**DOCUMENT ORDER CLARIFICATION**

<b>Title - Sujet</b> Hamilton, ON - Burlington Lift Brid	
<b>Solicitation No. - N° de l'invitation</b> EQ754-140817/A	<b>Date</b> 2013-08-07
<b>Client Reference No. - N° de référence du client</b> R.012641.001	<b>GETS Ref. No. - N° de réf. de SEAG</b> PW-\$PWL-030-1873
<b>File No. - N° de dossier</b> PWL-3-36030 (030)	<b>CCC No./N° CCC - FMS No./N° VME</b>
<b>Solicitation Closes - L'invitation prend fin</b> <b>at - à 02:00 PM</b> <b>on - le 2013-08-29</b>	
<b>Time Zone</b> <b>Fuseau horaire</b> Eastern Daylight Saving Time EDT	
<b>F.O.B. - F.A.B.</b> <b>Plant-Usine:</b> <input type="checkbox"/> <b>Destination:</b> <input checked="" type="checkbox"/> <b>Other-Autre:</b> <input type="checkbox"/>	
<b>Address Enquiries to: - Adresser toutes questions à:</b> Cowieson, Jim	<b>Buyer Id - Id de l'acheteur</b> pwl030
<b>Telephone No. - N° de téléphone</b> (416) 512-5829 ( )	<b>FAX No. - N° de FAX</b> (416) 512-5862

### **TENDER QUESTIONS AND RESPONSE**

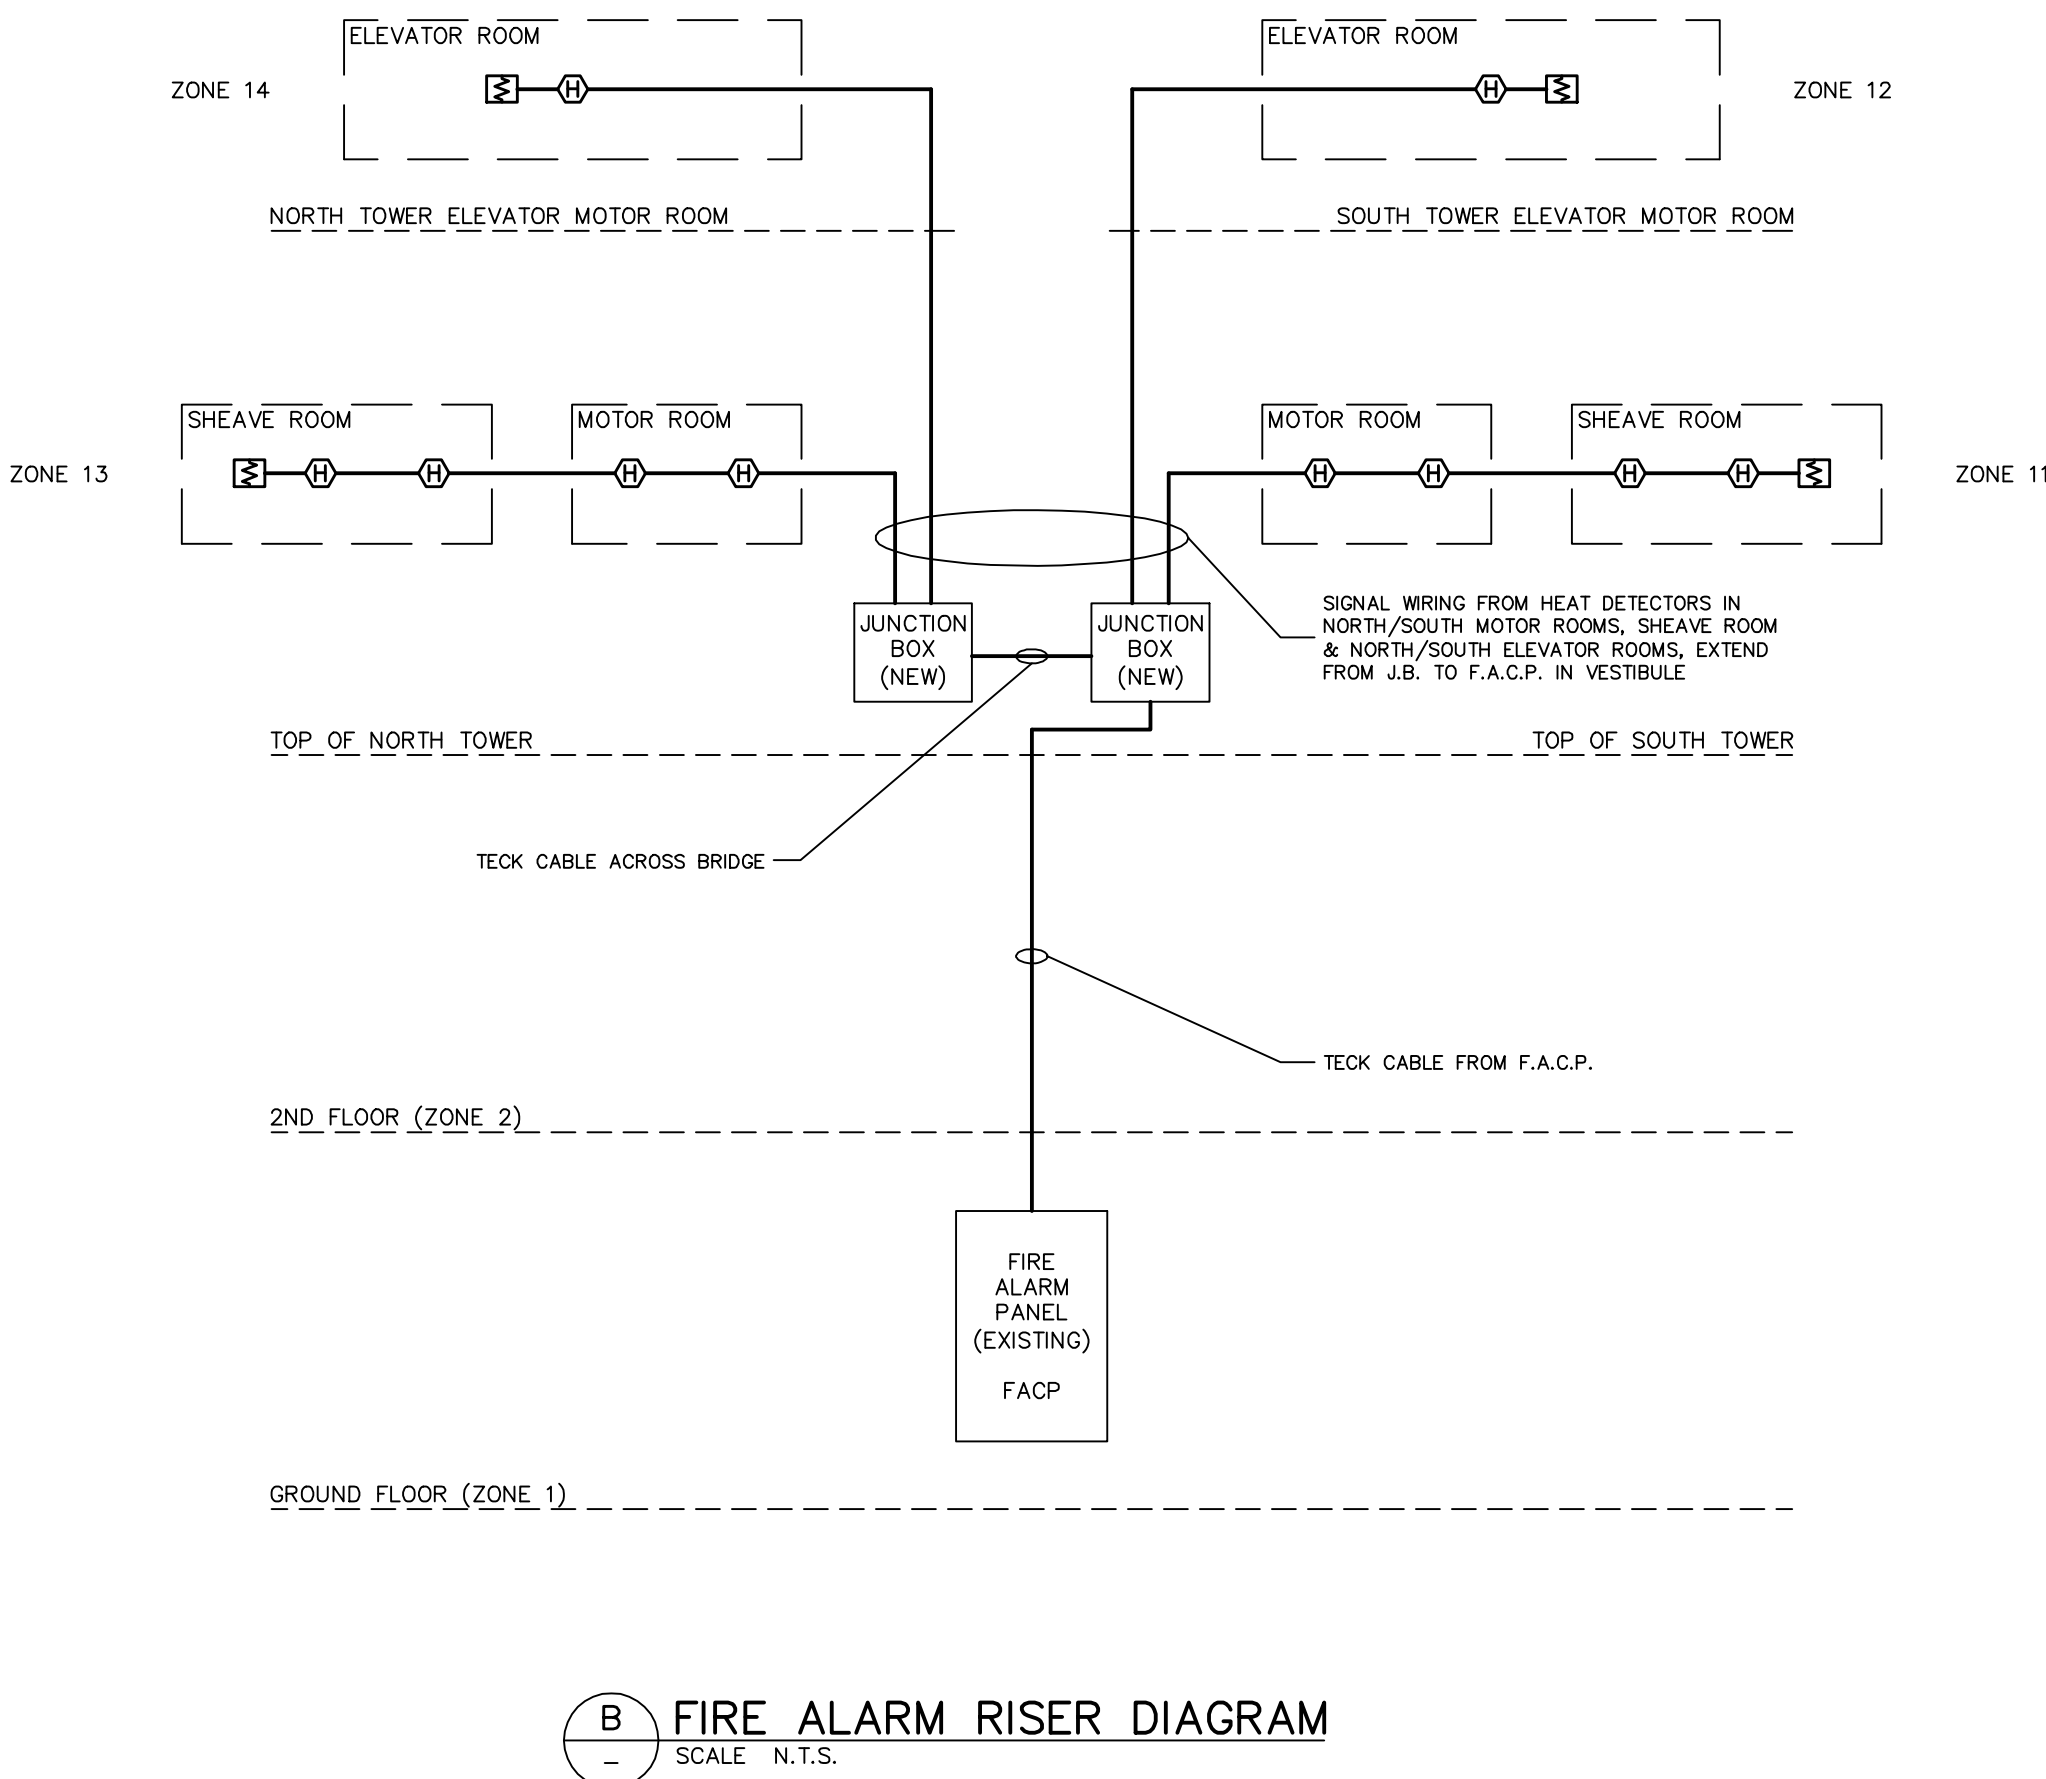
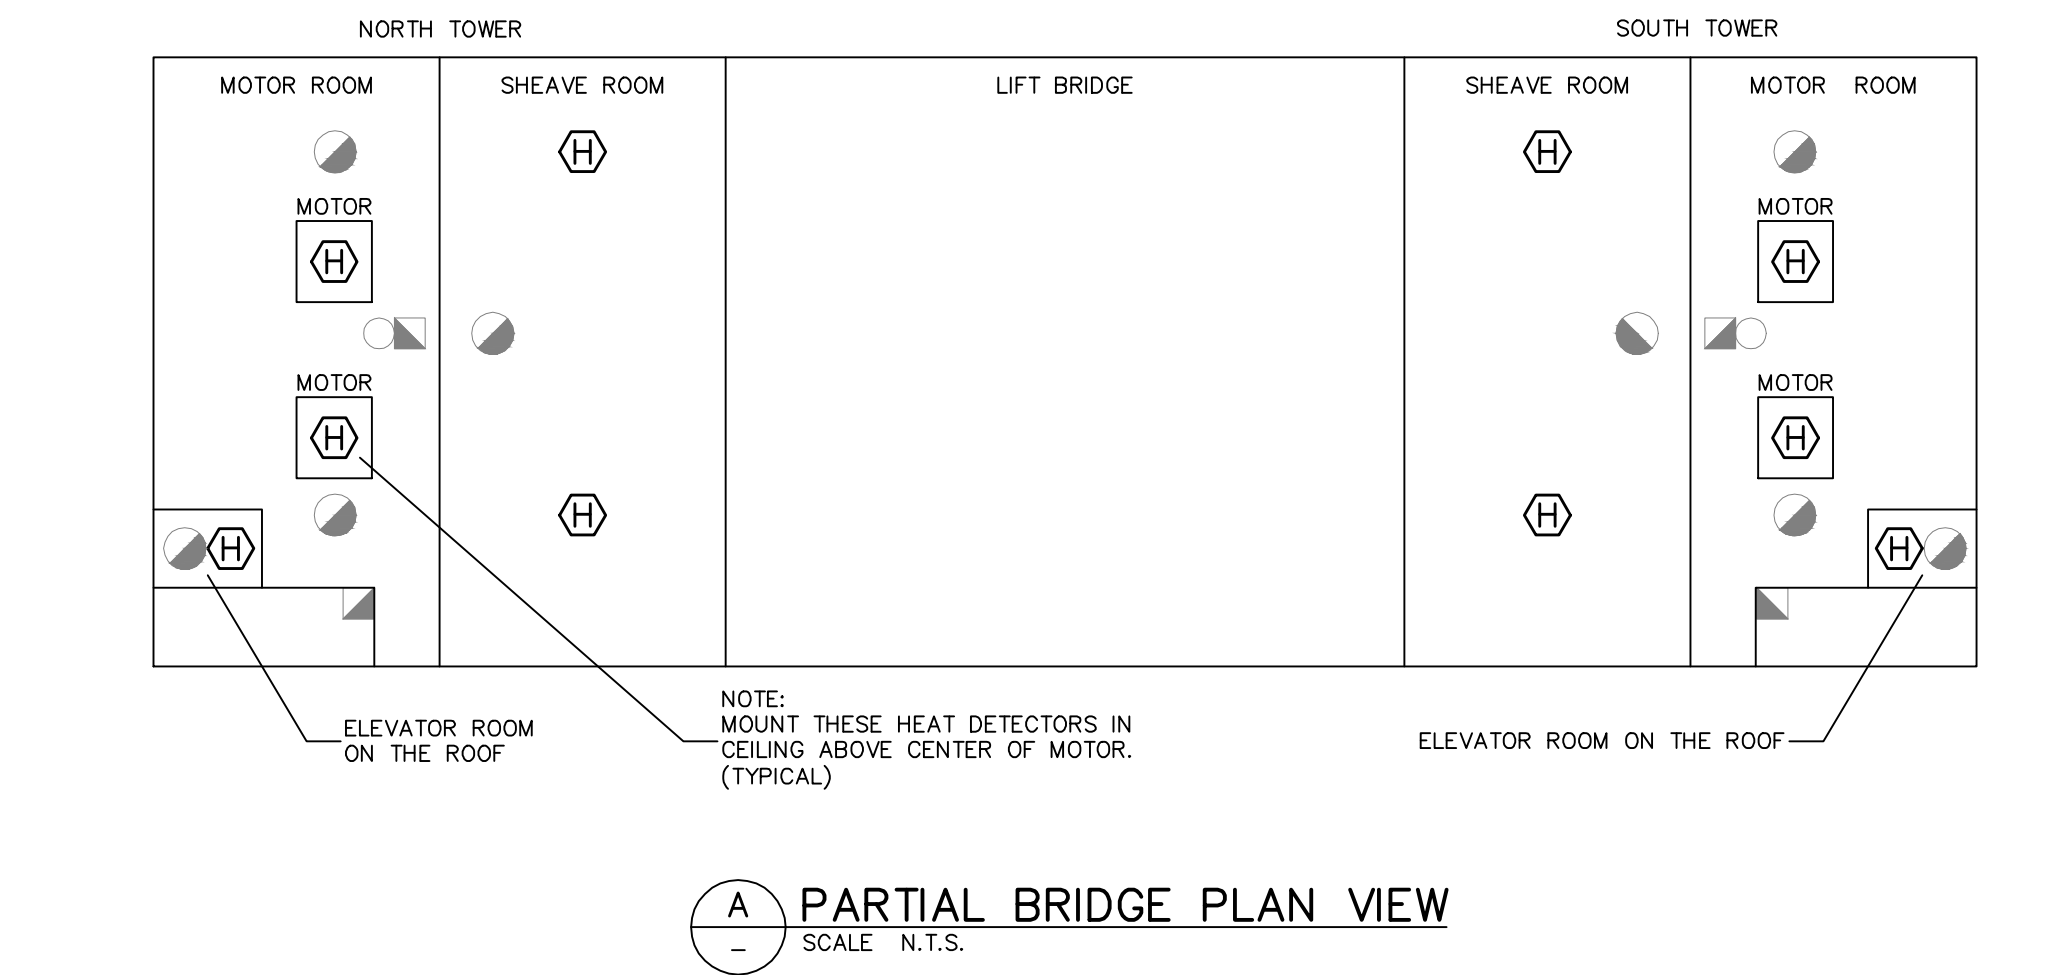
Q22 Re; Amendment 3 - Q4

The 4 additional drawings and photograph were not included in the download.

Please advise where these documents can be found.

Response: Attachments issued 29 October 2013 for posting on the Buy & Sell website.

**A** PTZ CAMERA JUNCTION BOX (EXAMPLE) – SEE NOTE 1 AND 3  
SCALE 1:2

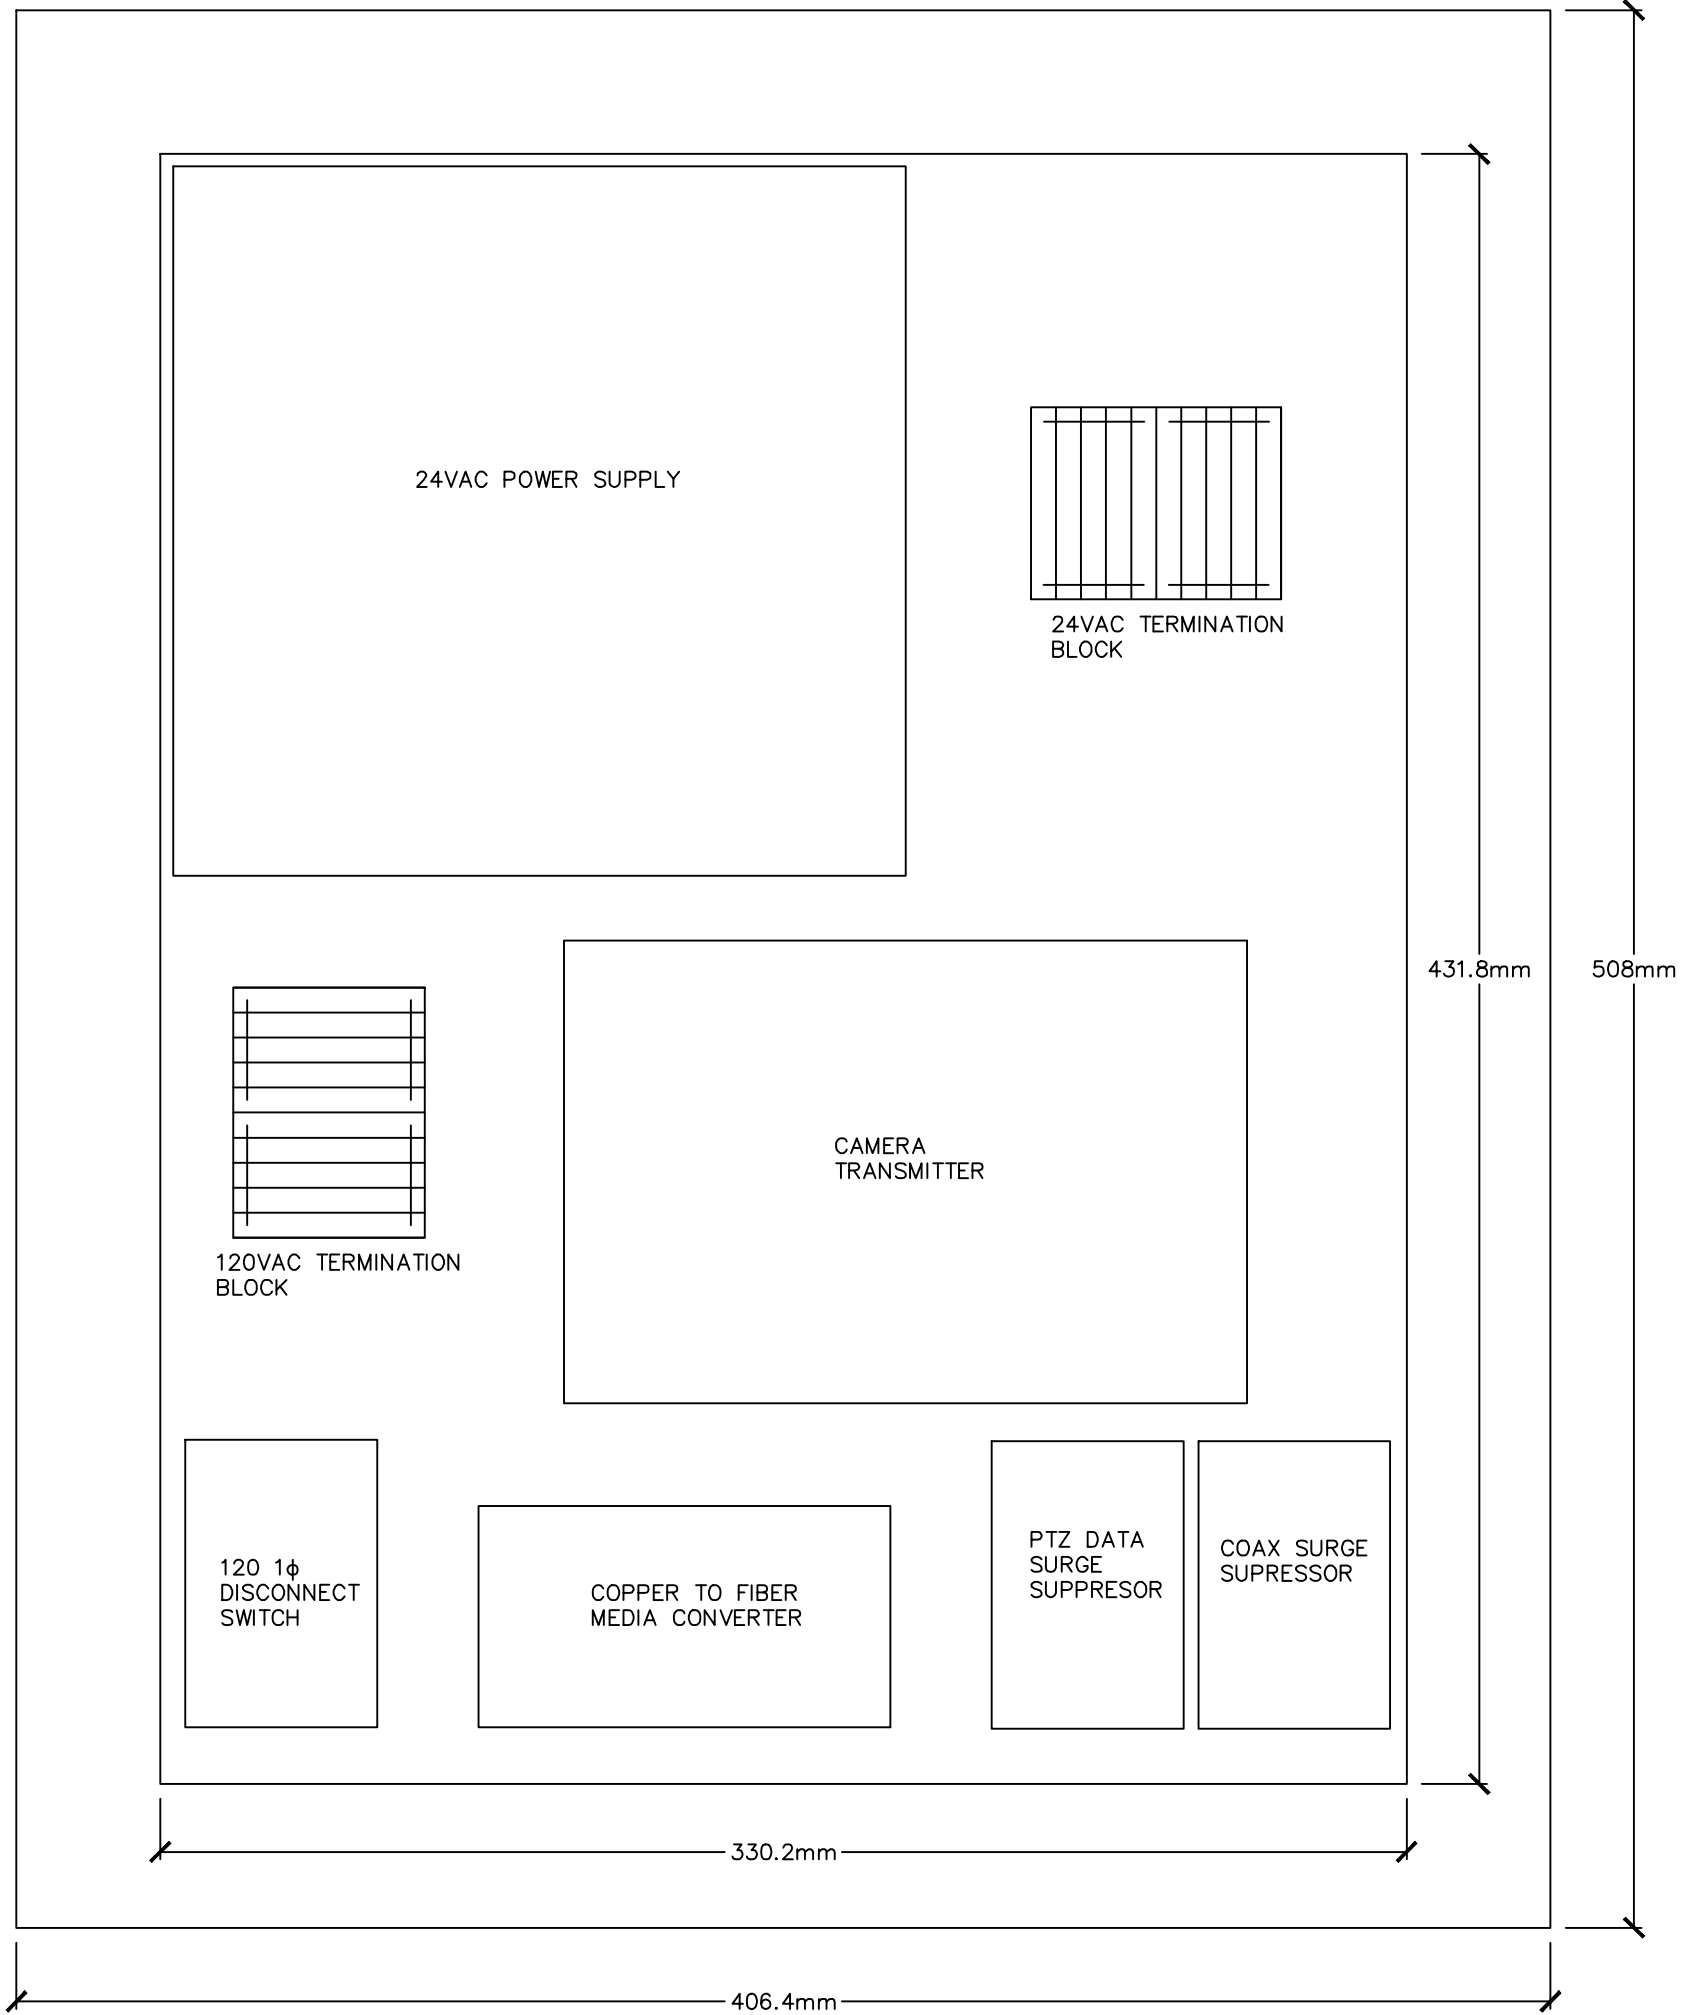
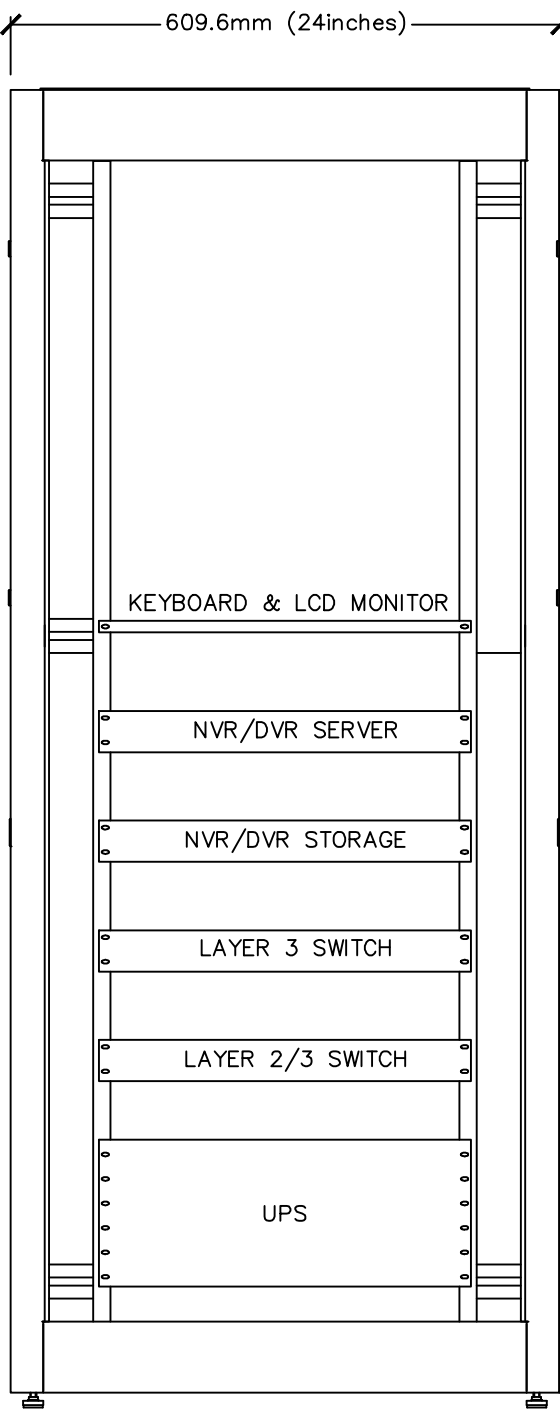
In response to Question # 6 above
